*Southern California Edison Company*

June 30, 1993

**Subject: Docket No. 50-206, Amendment Application No. 211, Supplement 1, Fuel Storage Facility Thermal and Structural Analyses, Permanently Defueled Technical Specifications, San Onofre Nuclear Generating Station, Unit 1**

**Figure 1. Spent Fuel Pool Heat Load During Permanently Defueled Condition**

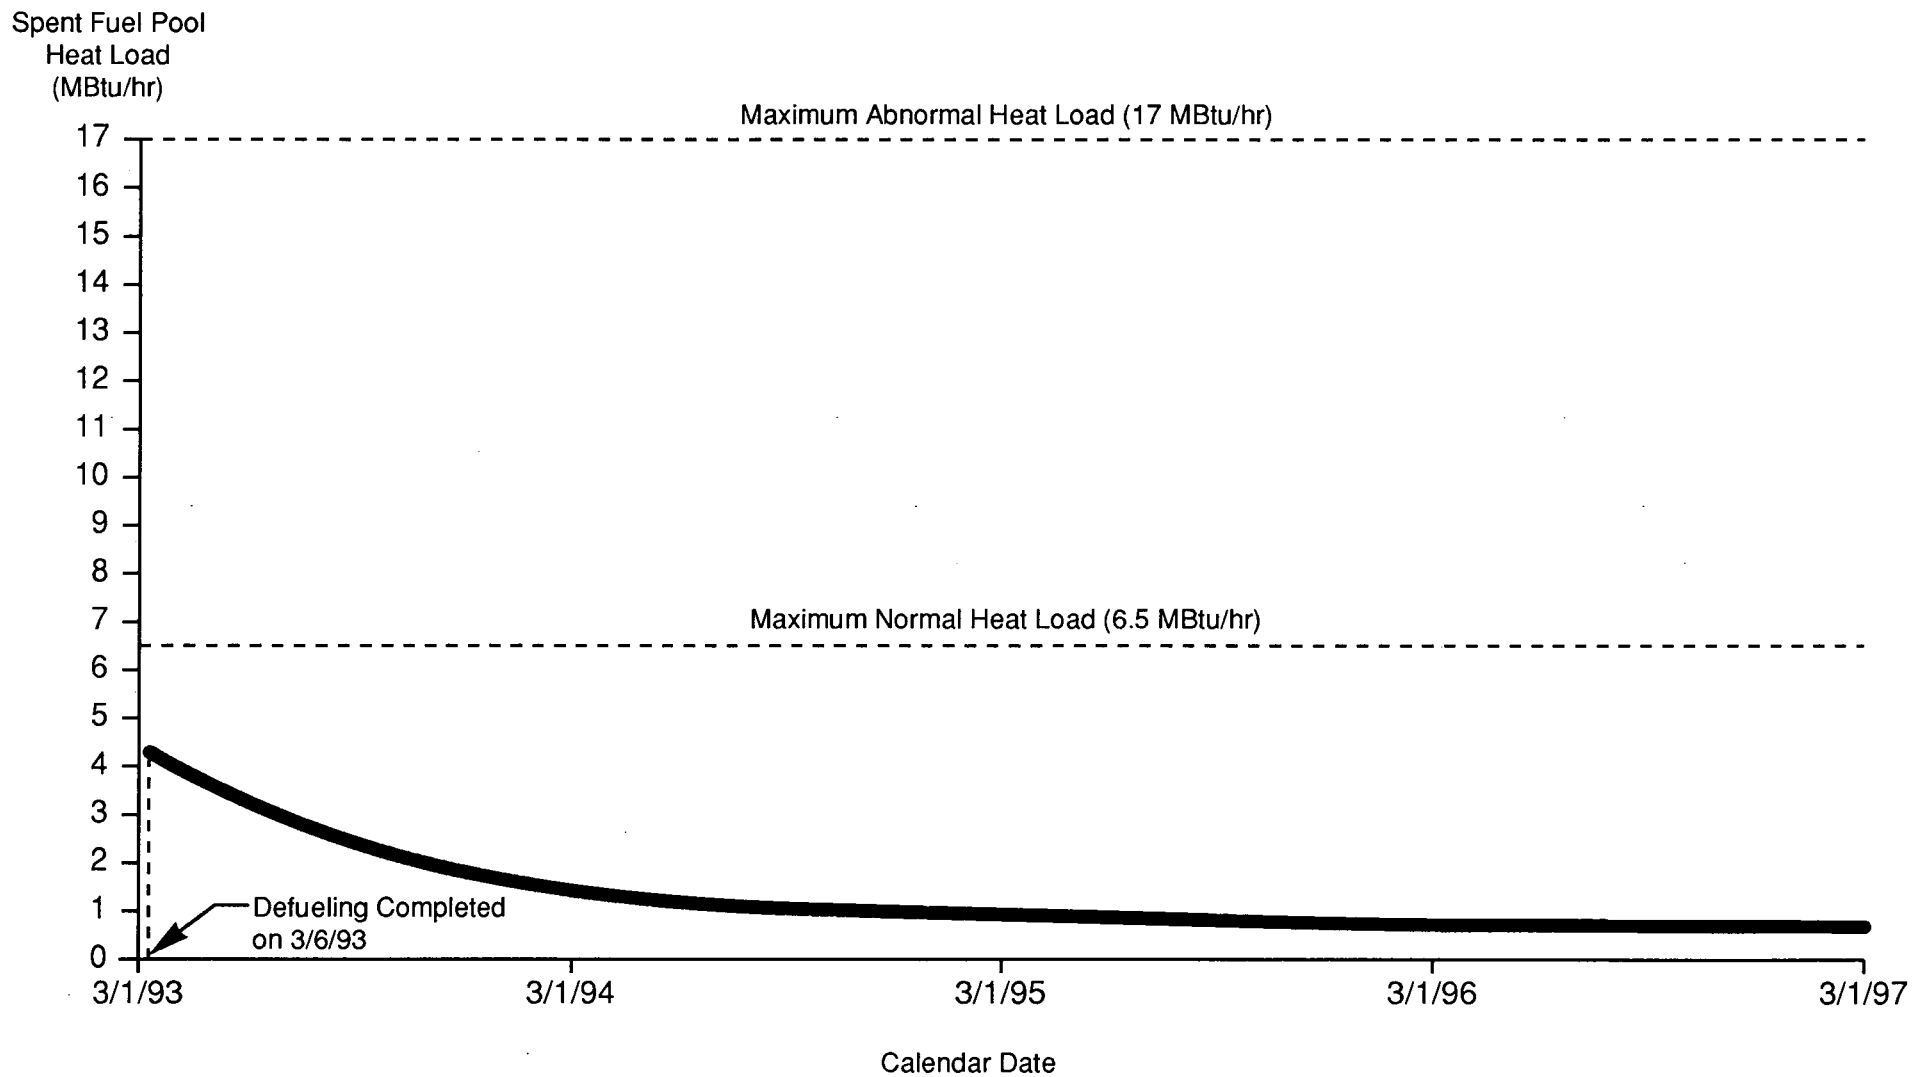
Most of the final results of the thermal analysis are identical to the corresponding preliminary results submitted earlier. Specifically, the SFP heat load (Figure 1) and time to heat up to 150°F (Figure 2) results are unchanged. Therefore, by August 1, 1993, the SFP heat load will be less than

Final versions of Figures 1, 2, and 3 in the amendment application are included in Enclosure 1 to support the Commission's review of the proposed PDTS. Each figure is noted as being final rather than preliminary. Additionally, the calendar date axis in Figure 1 has been rescaled slightly to correct a plotting discrepancy that was contained in the preliminary version of that figure.

**Figure 3. Spent Fuel Pool Equilibrium Temperature and Maximum Evaporation Rate With No Cooling in Operation (open fuel storage building rollup and personnel access doors)**

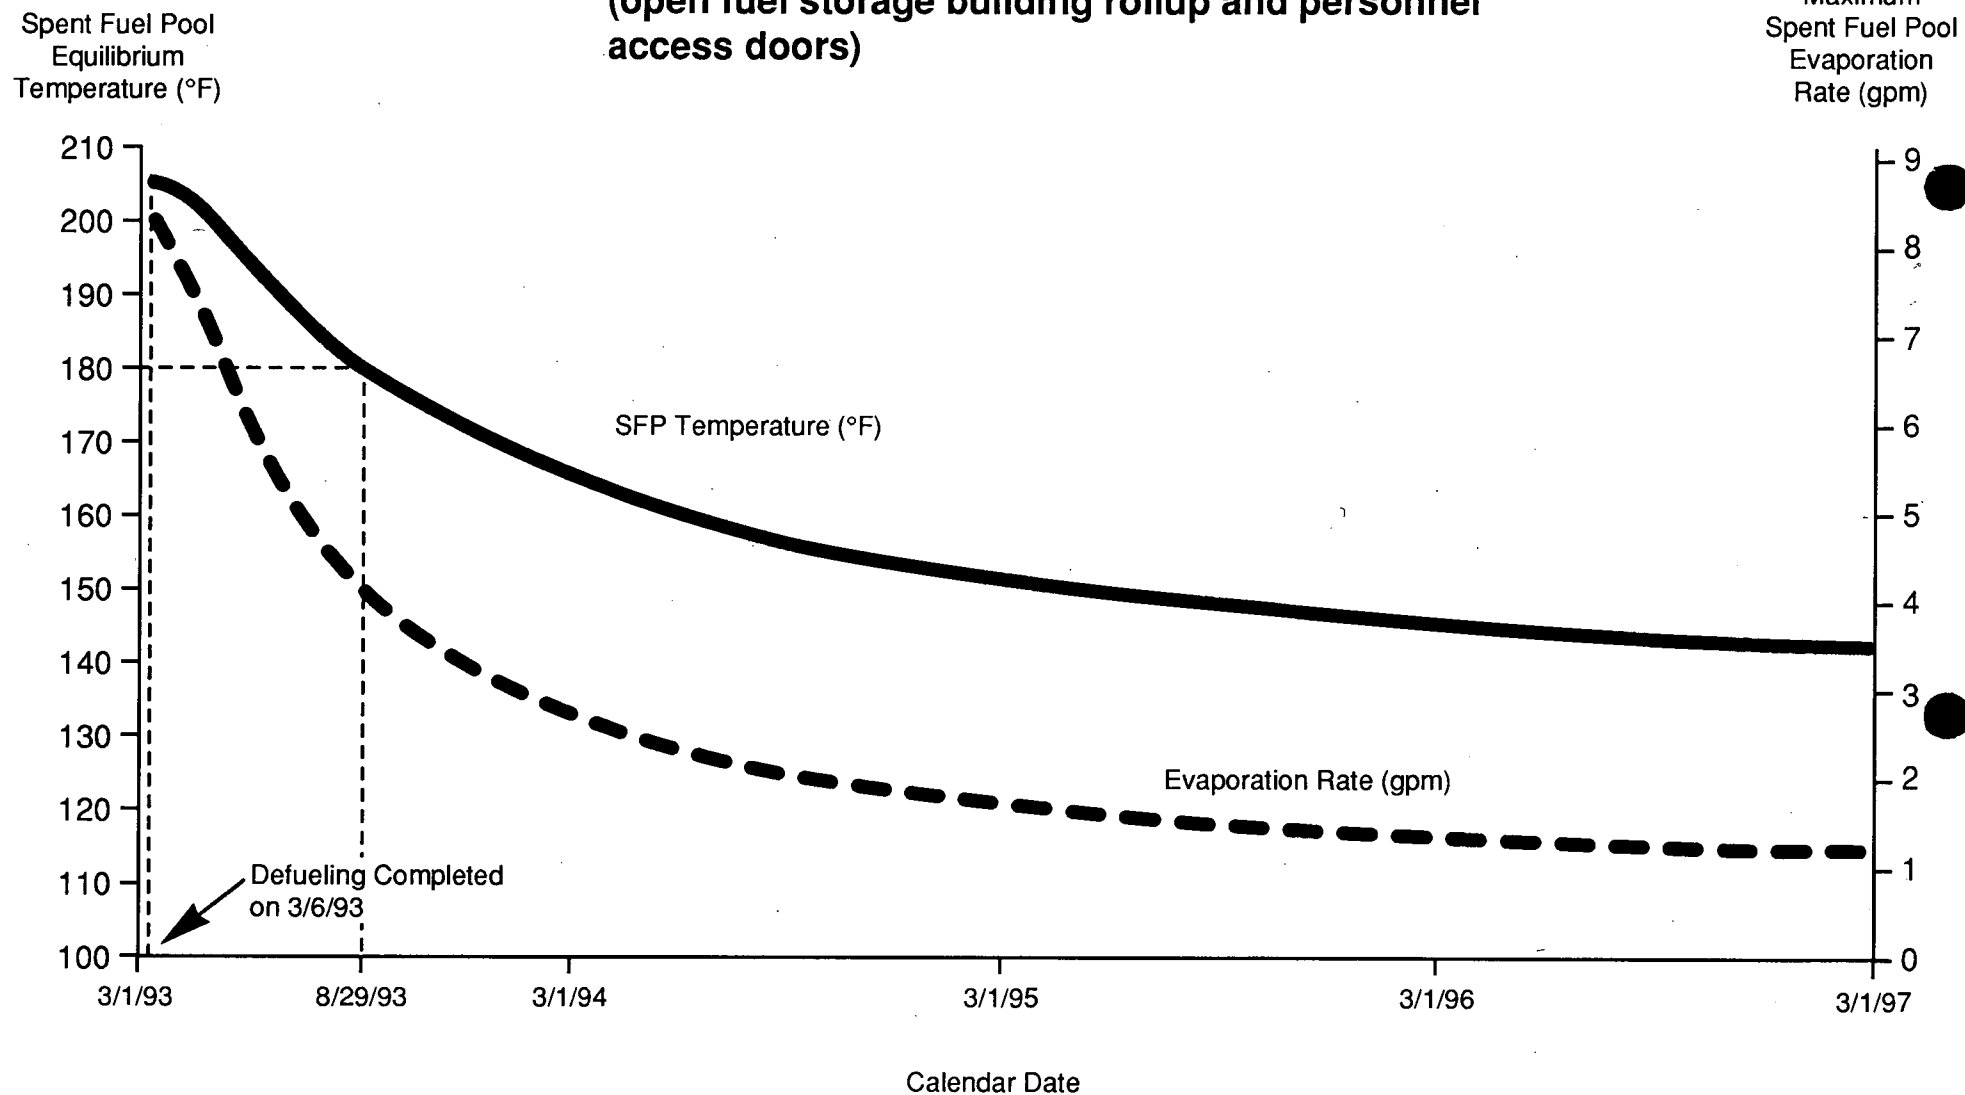
However, the final results for SFP equilibrium temperature and maximum evaporation rate during loss of cooling conditions differ slightly from the preliminary results included in Figure 3 of the amendment application. For example, the timing for an SFP equilibrium temperature of 180°F is projected for August 29, 1993, rather than the preliminary date of August 26, 1993. Additionally, the SFP maximum evaporation rate that could occur if forced cooling were lost after August 29, 1993, is 4.1 gpm rather than 4.5 gpm. The slight changes in the calculated parameters of Figure 3 are not significant. The conclusions of the PDTS significant hazards consideration analysis concerning the adequacy of SFP makeup water sources and the capability to passively cool the SFP are confirmed by the final analytical results.

The slight reduction in the calculated SFP maximum evaporation rate during loss of forced cooling conditions means the predicted rate for lowering of the SFP water level is less than previously indicated in Amendment Application No. 211. For example, the time stated in the Basis of proposed PDTS D3.2 for the SFP water level to drop within 10 feet of the stored fuel, assuming makeup remained unavailable, is conservatively calculated to be 24 days rather than 22 days. This result also supports the conclusions of the PDTS significant hazards analysis.
